SHOALHAVEN CITY COUNCIL
ENVIRONMENTAL ASSESSMENT SUBMISSION TO THE NSW DEPARTMENT
OF PLANNING PART 3A, ENVIRONMENTAL PLANNING & ASSESSMENT ACT, 1979

MAJOR PROJECT APPLICATION MP 06_0205

Vincentia District Centre
Modification No 5

PROPOSAL: Proposed MP06_0205 VDC Stage 1 - Modification No 5 being a modification to the VDC Stage 1 approvals issued in Modifications 2, 3, and 4.
Delivery of the VDC in two stages with an amended floor layout design and Statement of Commitments and proposals for a fuel and fast food outlet in Stage 1.

BBLC Masterplan and new access road design at Access E

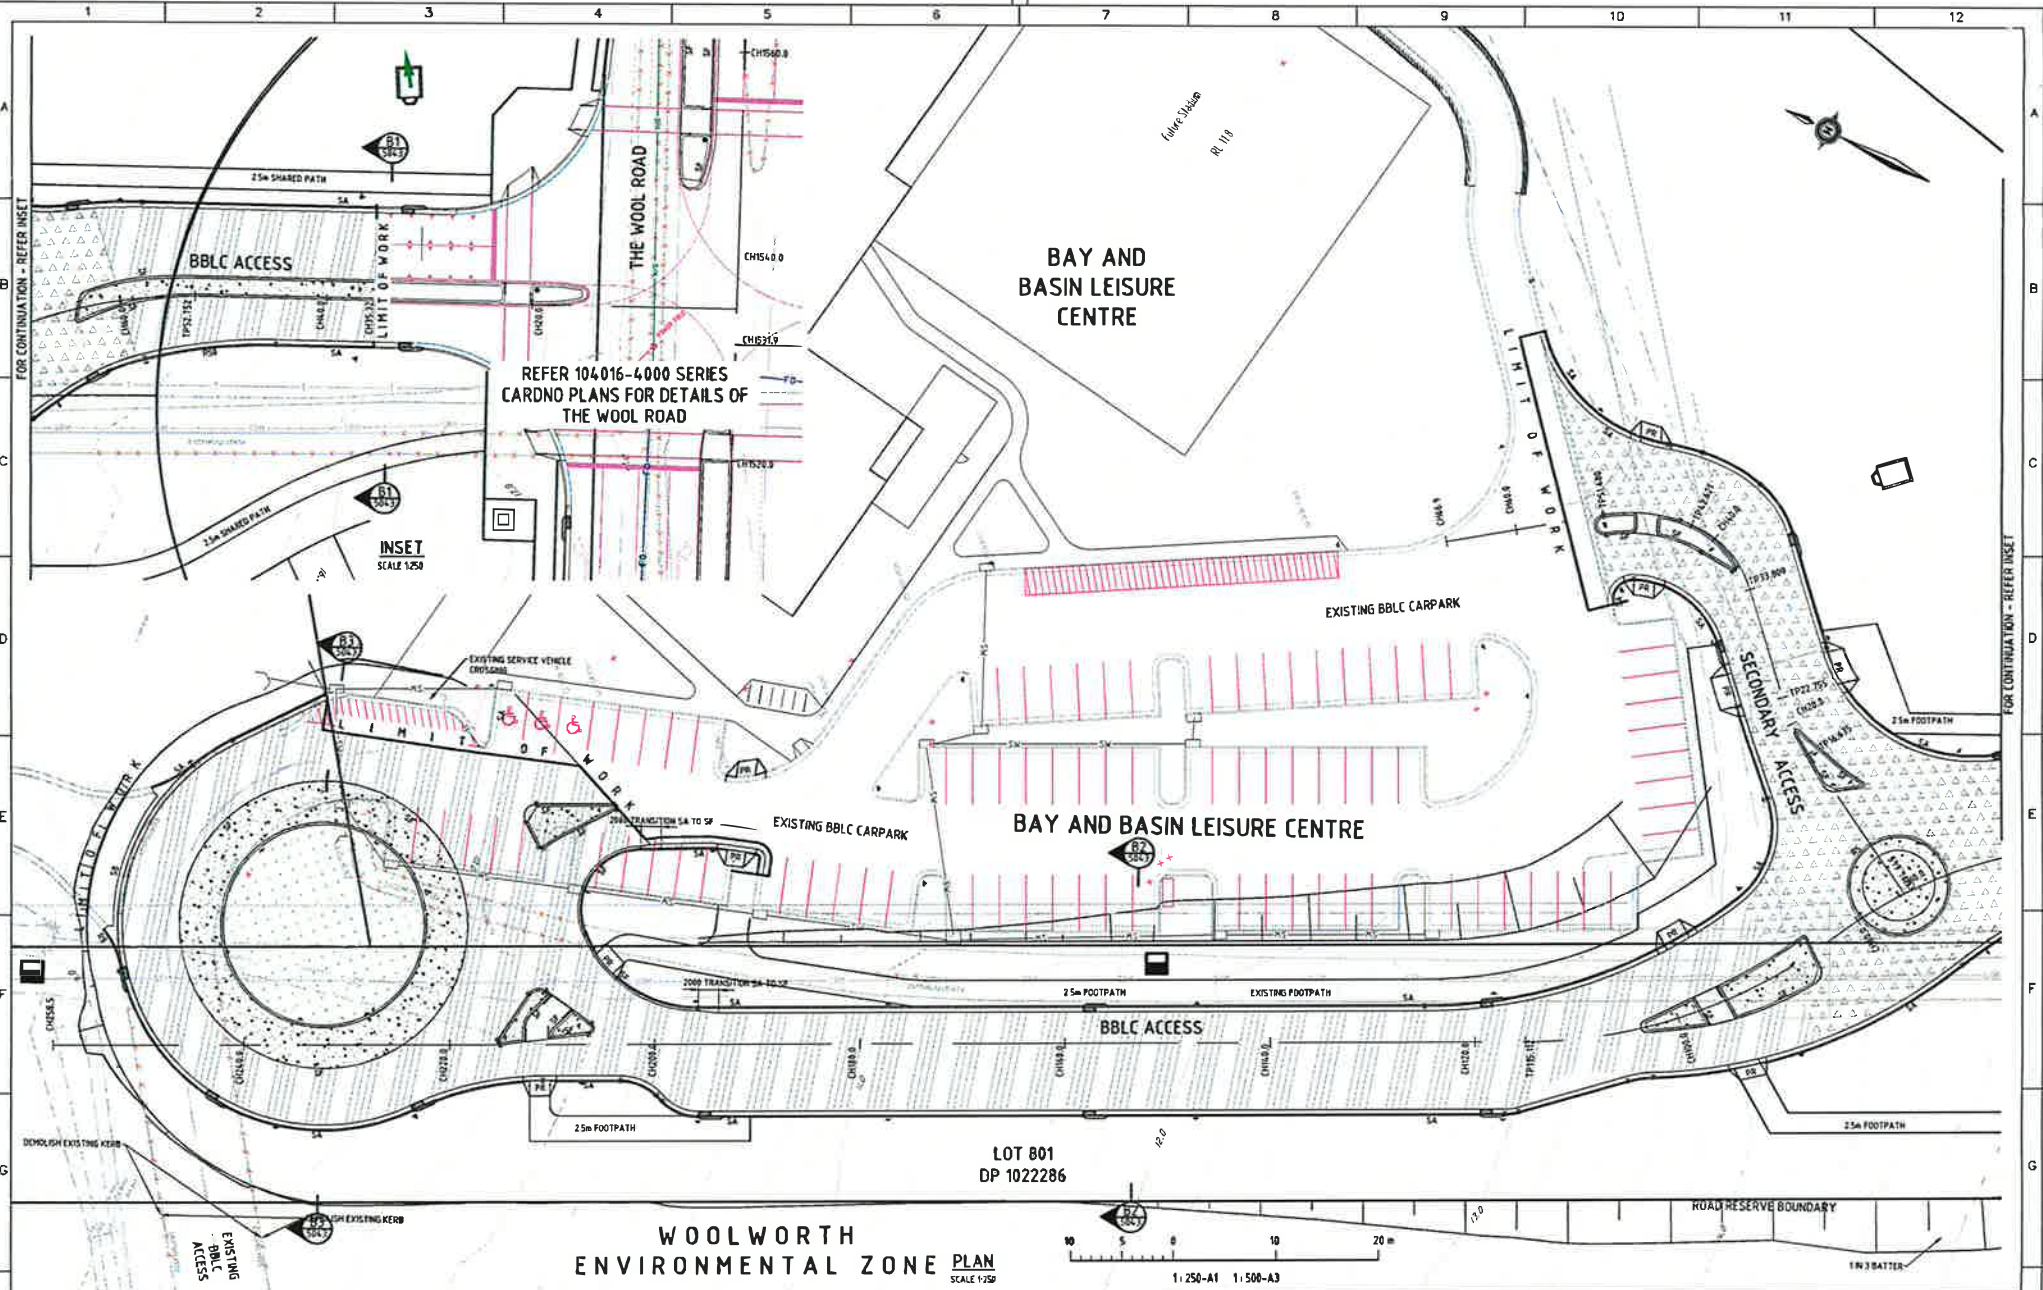
A copy of the Masterplan for the BBLC and the currently agreed new access road to the BBLC is attached as **Appendix 1**

Council requires an equivalent usage for the new access for buses, delivery vehicles and light vehicles that need to access the BBLC based on the new orientation of the road. Earlier discussions with Fabcot's consulting engineers led to an acceptable design and included a partial cost share to achieve the desired and workable solution.

It is understood that Woolworths may propose to construct an access road that includes only a two lane formation with limited facilities and less controlled at the intersection with TWR and no provisions at the high school entrance for traffic and pedestrians as previously approved. Council considers such an approach needs to form part of an overall traffic solution that addresses the issues outlined above.
